COUNCIL ASSESSMENT REPORT

Panel Reference	2017SNH069
DA Number	117/2017
LGA	Lane Cove Council
Proposed Development	Construction of a seniors housing development comprising 70-bed residential aged care facility, 82 independent living units/self-contained dwellings, with basement car parking for 122 vehicles, new public park and facilities and landscaped through-site link.
Street Address	266 Longueville Road Lane Cove
Applicant/Owner	Australian Unity Limited / Lane Cove Council
Date of DA lodgement	10 August 2017
Number of Submissions	186 (first notification) 97 (second notification)
Recommendation	Deferred Commencement Consent
Regional Development Criteria (Schedule 7 of the SEPP (State and Regional Development) 2011)	Total Cost of the Development is \$81,345,000.00
List of all relevant s4.15(1)(a) matters	<ul style="list-style-type: none"> • State Environmental Planning Policy No. 55 – Remediation of Land • State Environmental Planning Policy (Building Sustainability Index: BASIX) • State Environmental Planning Policy – Infrastructure 2011 • State Environmental Planning Policy No 65 – Design Quality of Residential Apartment Development • State Environmental Planning Policy (Housin

Figure 4: Relationship to adjoining Bushland. Source: Mollino Stewart 22 May 2018

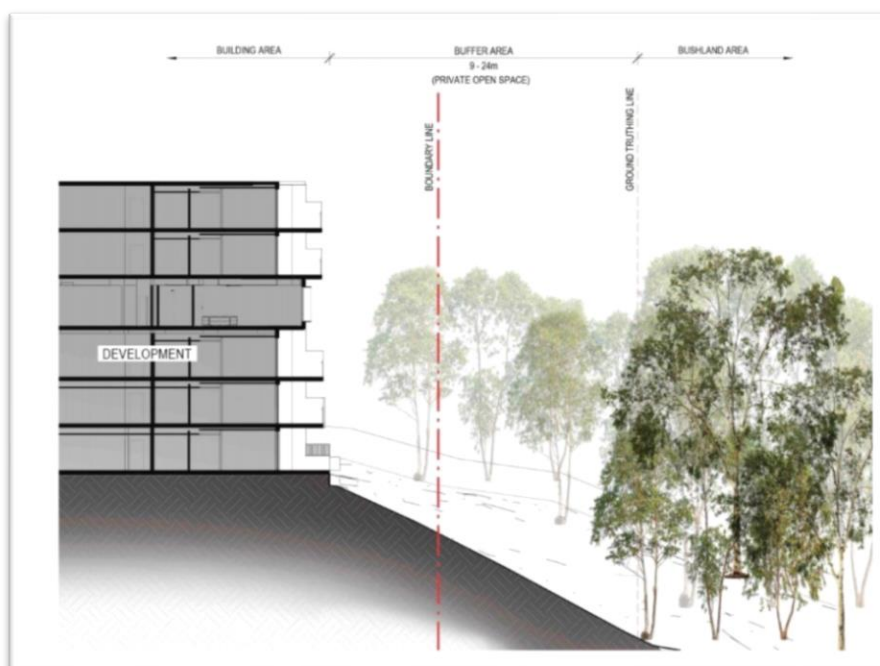
The eastern end of the proposed building has a setback to the boundary of between 5.1 and 10.7m. This part of the building is located close to existing ground level, requiring minimal excavation. The applicant has ground-truthed the location of the bushland and has shown that there will be no impact on the adjoining bushland. Multiple conditions are proposed to ensure the protection trees and bushland. **It is considered that the consent authority can be satisfied in relation to SEPP 19.**

Figure 1: Southern Elevation Showing Extent of Non-Compliance

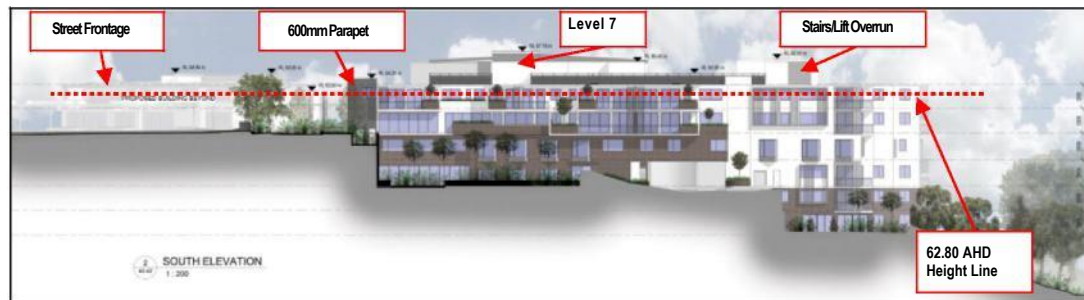
The height of the proposal varies across the site and within each of the proposed buildings (see Table 1 and Figure 1 on the following page). Broadly speaking, there are three predominant areas of non-compliance which will be outlined individually below.

The lift overruns and stairs servicing the respective buildings are the highest points of the development. However, these are setback from both the property boundaries and from the leading edge of the buildings (see Figure 2). It is noted that the centrally located rooftop landscaped courtyard is also located above the height limit.

Figure 2: Level 7 Floor Plan Showing Units and Services

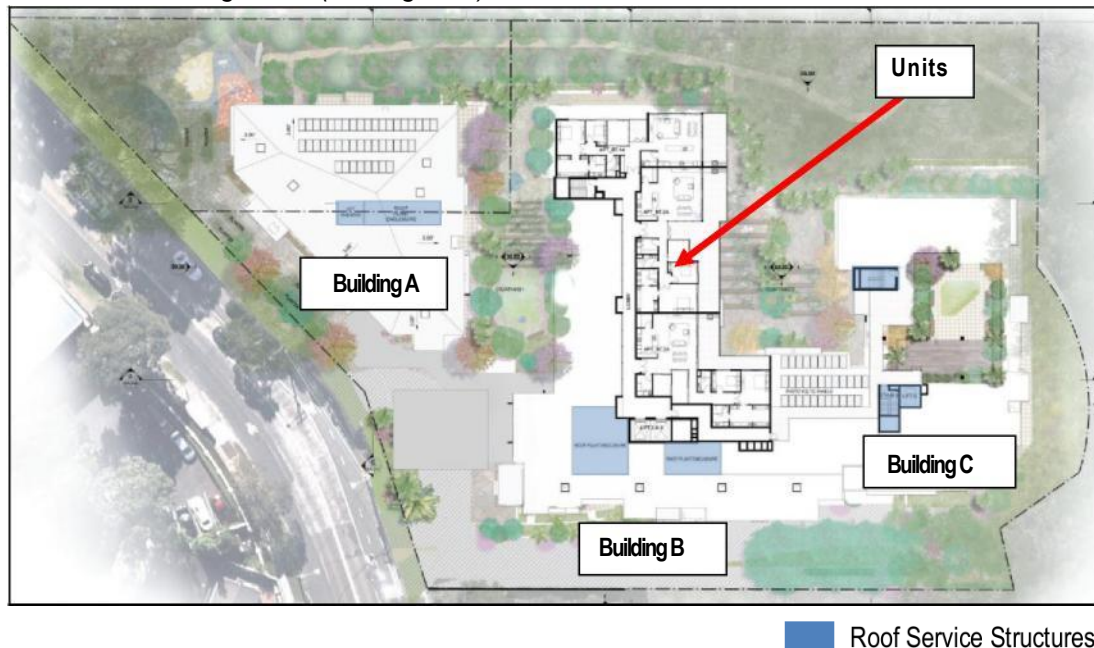
Three 2 bedroom units are proposed on Level 7 with a pitched roof height of RL 67.01 which is 4.21m over the height limit (see Figure 2).

Variation No. 4 relates to the three two-bedroom aged care units located on Level 7 as part of Building B in the middle of the site. These have been moved from the rear of the site in accordance with the Independent Assessor's advice in order to reduce the visual impact resulting from the sloping site. The number of units on the upper level have been reduced and further set back from the original DA submission. This will enhance the privacy of the adjoining residential flat building at Nos. 268-270 Longueville Road. The relocated Level 7 will continue to provide a considerable building separation from 'Timbertops', well in excess of the ADG requirements.

Figure 10: Southern Elevation: Source: Thomson Adsett Architects

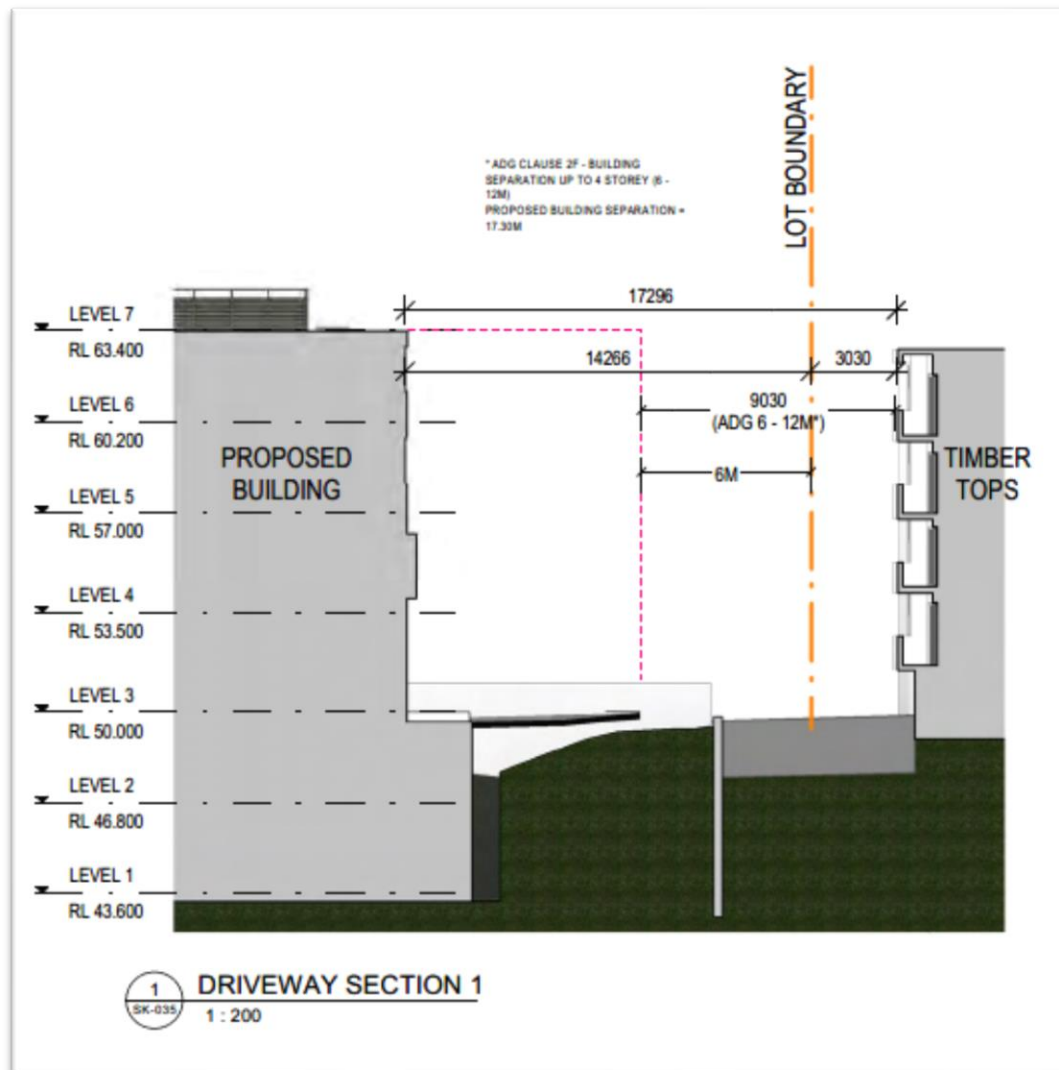
It is noted that not all levels can be viewed from the south as the lower two levels are below the level of the driveway. The applicant has varied the balconies from the original plans, reducing the setback of some and providing planter boxes to others.

To provide better amenity for the residents to the south it is considered that additional deep soil planting should be introduced along the southern boundary. A 2-metre wide strip could be achieved by narrowing the width of the driveway by 1 metre (which still retains a minimum width of 6 metres) and by moving the proposed building 1 metre to the north. Given the design of the northern side of the building and the large setbacks to the northern boundary, it is considered that this would not create any additional amenity impacts on residences adjoining the northern boundary. However, a more suitable visual screen and landscape buffer will be provided to the south.
